## Technical Memorandum

**TO:** Mr. Alan Day, General Manager  
Brazos Valley Groundwater Conservation District

**SUBJECT:** Review of DTB Investments LP Carrizo Aquifer and Simsboro Aquifer Evaluation Report

**DATE:** September 1, 2023

Figure 1. Proposed DTB Investments LP Well Location Map

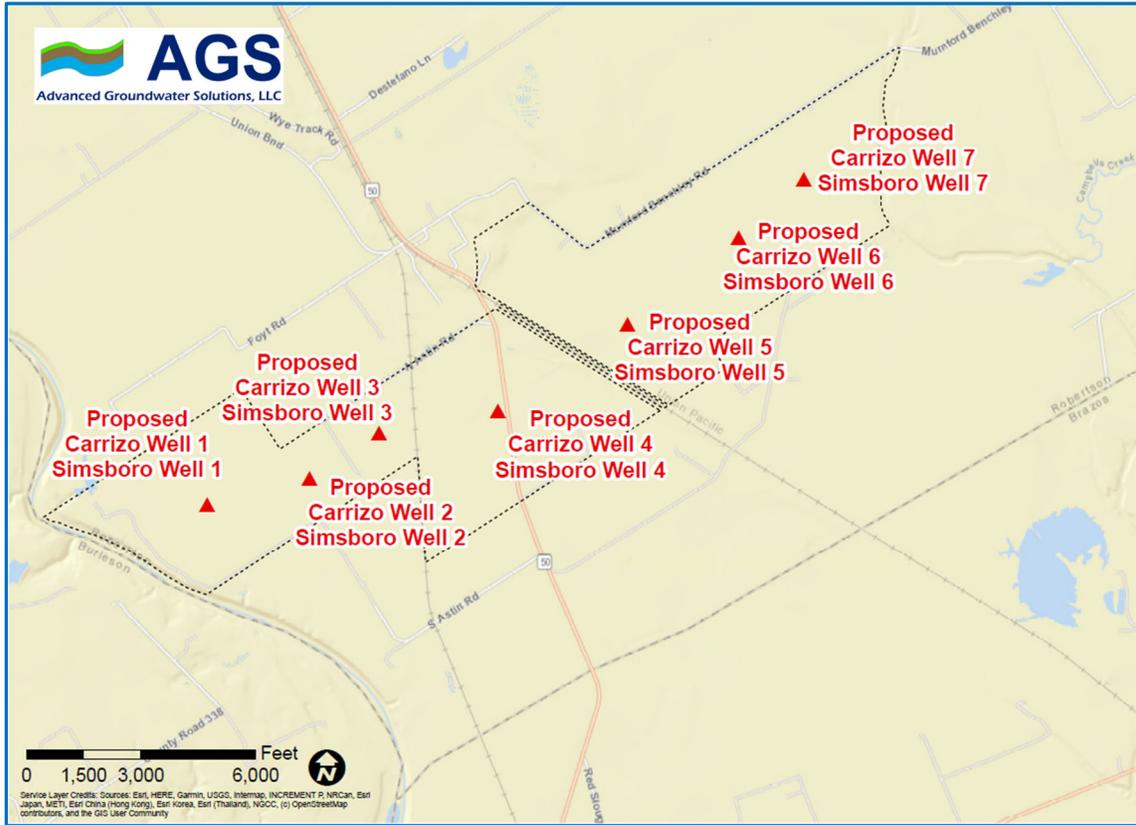
The proposed DTB Carrizo and Simsboro wells are planned to be paired so that one Carrizo well and one Simsboro well will be completed at each location. The Carrizo and Simsboro wells are planned to be spaced about 50 feet apart. The locations of Carrizo Well 7 and Simsboro Well 7 have been modified from the estimated locations shown in the TGI AER. The updated latitudes and longitudes provided on July 20, 2023 by TGI for the proposed Carrizo Well 7 is 30.7379054835 / -96.5316828807 and 30.7377996553 / -96.5317988591 for proposed Simsboro Well 7. The locations of the 14 proposed DTB wells are shown on Figure 1 below.

Figure 2. AGS This Analytical Simulated Carrizo Aquifer Drawdown After Proposed DTB Investments LP Carrizo Pumping of 7,612 ac-ft/yr for 10-Years

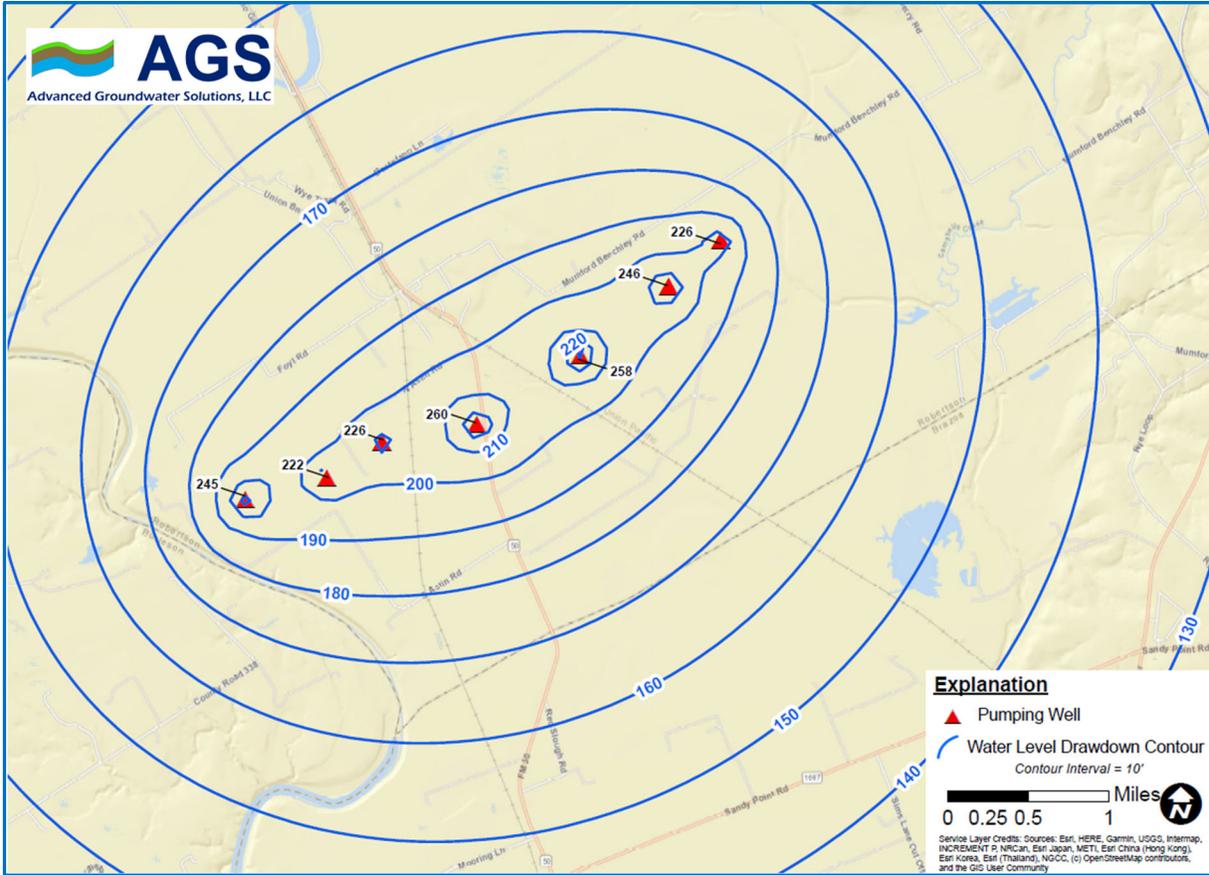
AGS simulated the drawdown at the pumping wells using the Theis analytical model and estimated the drawdown at one foot from the well. A transmissivity of 25,000 gpd/ft and a storage value of 0.000133 were used in the AGS Carrizo Aquifer analytical simulations with each proposed DTB Carrizo well pumping its average annual production rate. The transmissivity and storage values used in the AGS analytical simulations represent an average of the Carrizo Aquifer parameters in the GAM at the proposed DTB well locations. AGS was able to generally recreate the 1-year simulation results of the TGI Carrizo analytical modeling. The TGI 10-year Carrizo analytical simulation appears to underestimate the drawdown compared to simulations performed by AGS using the aquifer parameters as described above. Simulated drawdown could be less if TGI used

a larger storage value in the 10-year simulation. Figure 2 below shows the estimated AGS Carrizo analytical modeling drawdown contours that result from pumping 7,612 ac-ft/yr for 10-years.

Figure 3. AGS This Analytical Simulated Simsboro Aquifer Drawdown After Proposed DTB Investments LP Simsboro Pumping of 15,227 ac-ft/yr for 10-Years

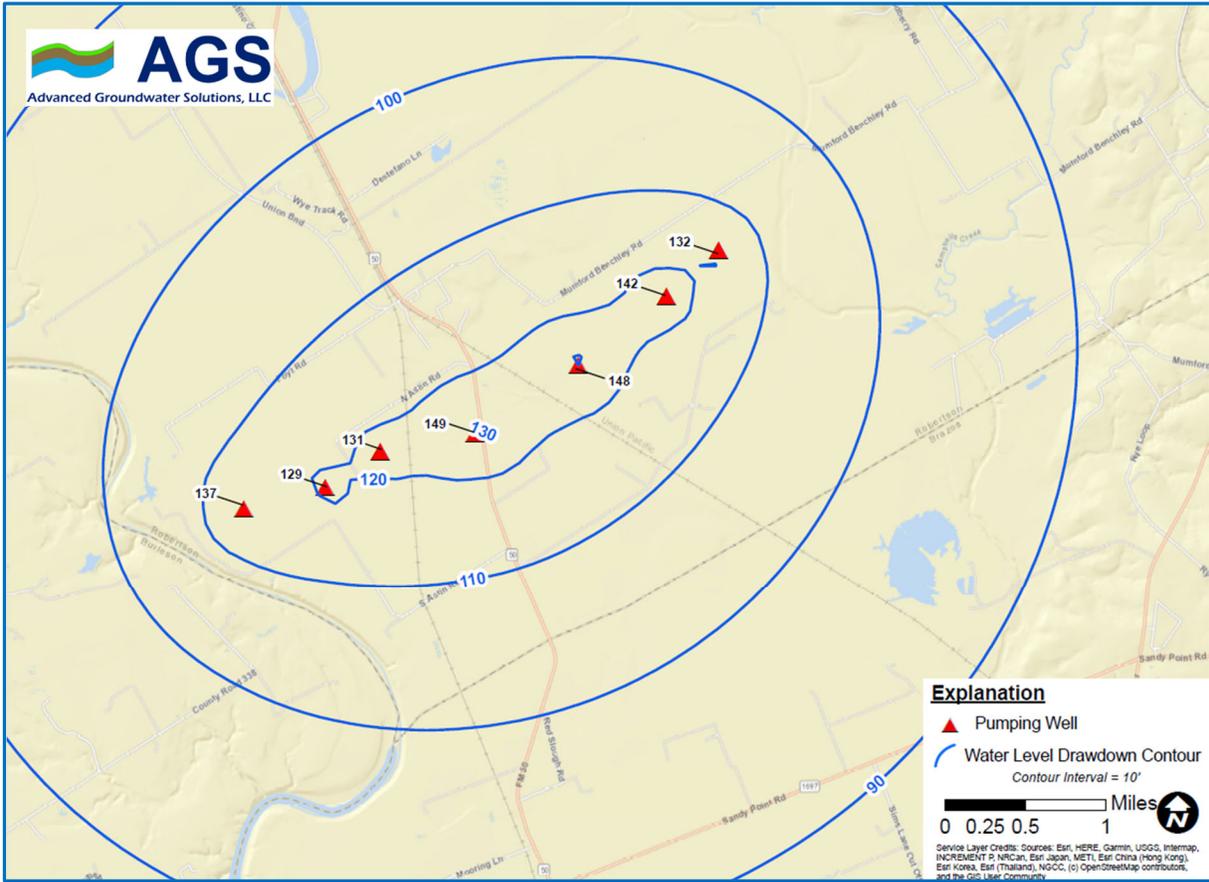
A transmissivity of 161,833 gpd/ft and a storage value of 0.000125 were used in the AGS Simsboro Aquifer analytical simulations with each proposed DTB well pumping its average annual production rate. The transmissivity and storage values used in the AGS analytical simulations represent an average of the Simsboro Aquifer parameters in the GAM at the proposed DTB well locations. AGS was able to generally recreate the 1-year simulation results of the TGI Simsboro analytical modeling. The TGI 10-year Simsboro analytical simulation appears to underestimate the drawdown compared to simulations performed by AGS using the aquifer parameters as described above. Simulated drawdown could be less if TGI used a larger storage value in the 10-year simulation. Figure 3 below shows the estimated AGS Simsboro analytical modeling drawdown contours that result from pumping 15,227 ac-ft/yr for 10-years.

Figure 4. Projected DFC Water Level Change at Proposed DTB Investments LP Carrizo Well 1 and Simsboro Well 1

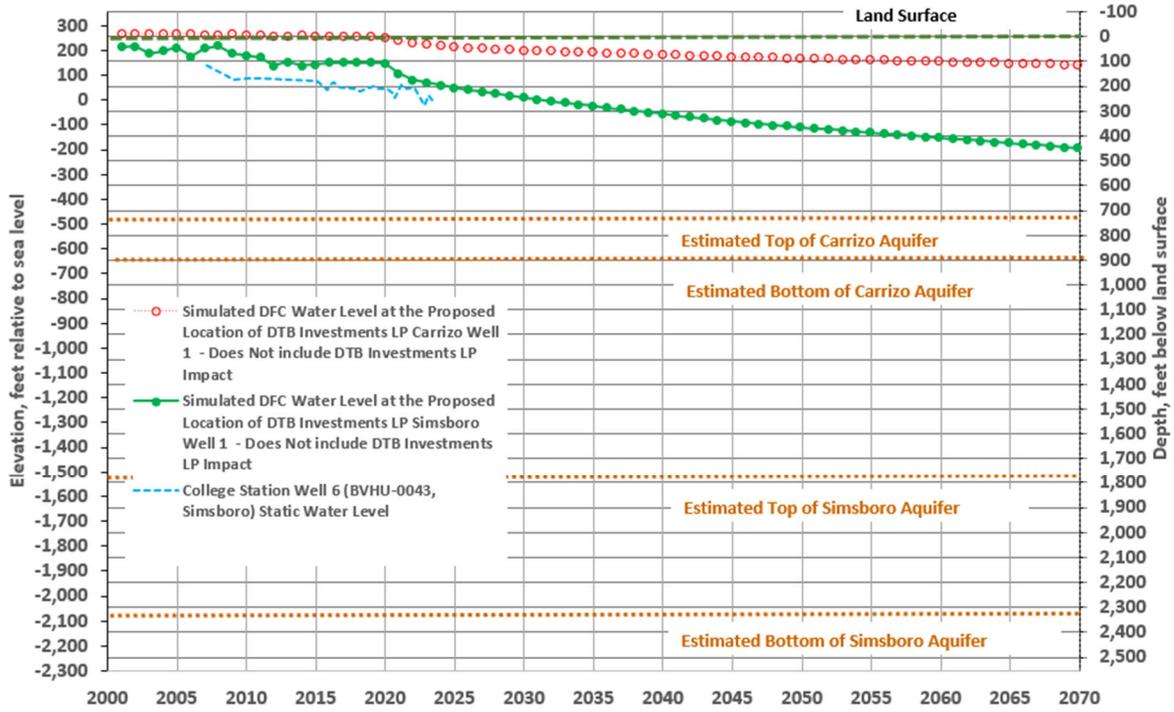
The City of College Station Well 6 (BVGCD BVHU-0043) screen sands of the Simsboro Aquifer in the depth interval of about 2,352 to 2,876 feet below land surface. Water levels available for the City of College Station Well 6 are shown on Figure 4. BVHU-00043 is located about 5.1 miles east-southeast of proposed DTB Simsboro Well 1. The College Station Well 8 (BVGCD BVDO-0053) water levels are shown on Figure 9. The well screen sands of the Simsboro Aquifer in the depth interval of about 1,976 to 2,749 feet bgl. BVDO-0053 is located about 2.5 miles southeast of proposed DTB Simsboro Well 6. The City of College Station Well 9 (BVGCD BVDO-0152) screens sands of the Simsboro Aquifer in the depth interval of about 2,088 to 2,444 feet bgl. The BVDO-0152 static water levels are shown on Figure 10 and the well is located about 1.7 miles southeast of proposed DTB Simsboro Well 7.

Figure 7. Projected DFC Water Level Change at Proposed DTB Investments LP Carrizo Well 4 and Simsboro Well 4

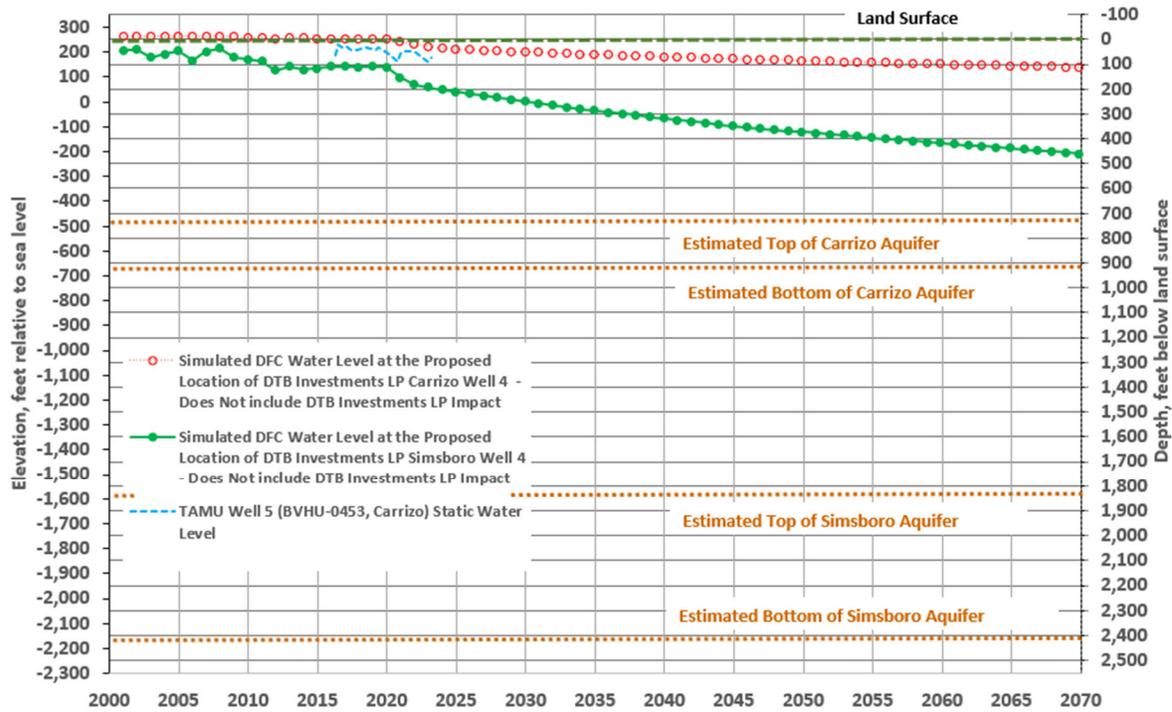
Texas A&M University Well 5 (BVGCD BVHU-0453) screens sands of the Carrizo Aquifer in the approximate depth interval of about 1,120 to 1,330 feet bgl and is located about 4.9 miles southeast of proposed DTB Carrizo Well 4. Available water level data for BVHU-0453 is shown on Figure 7. The City of College Station Carrizo Well 1 (BVGCD BVDO-0001) water levels are shown on Figure 8 and the well screen sands of the Carrizo Aquifer in the depth interval of about 1,120 to 1,340 feet bgl. BVDO-0001 is located about 4 miles southeast of the proposed DTB Carrizo Well 5.
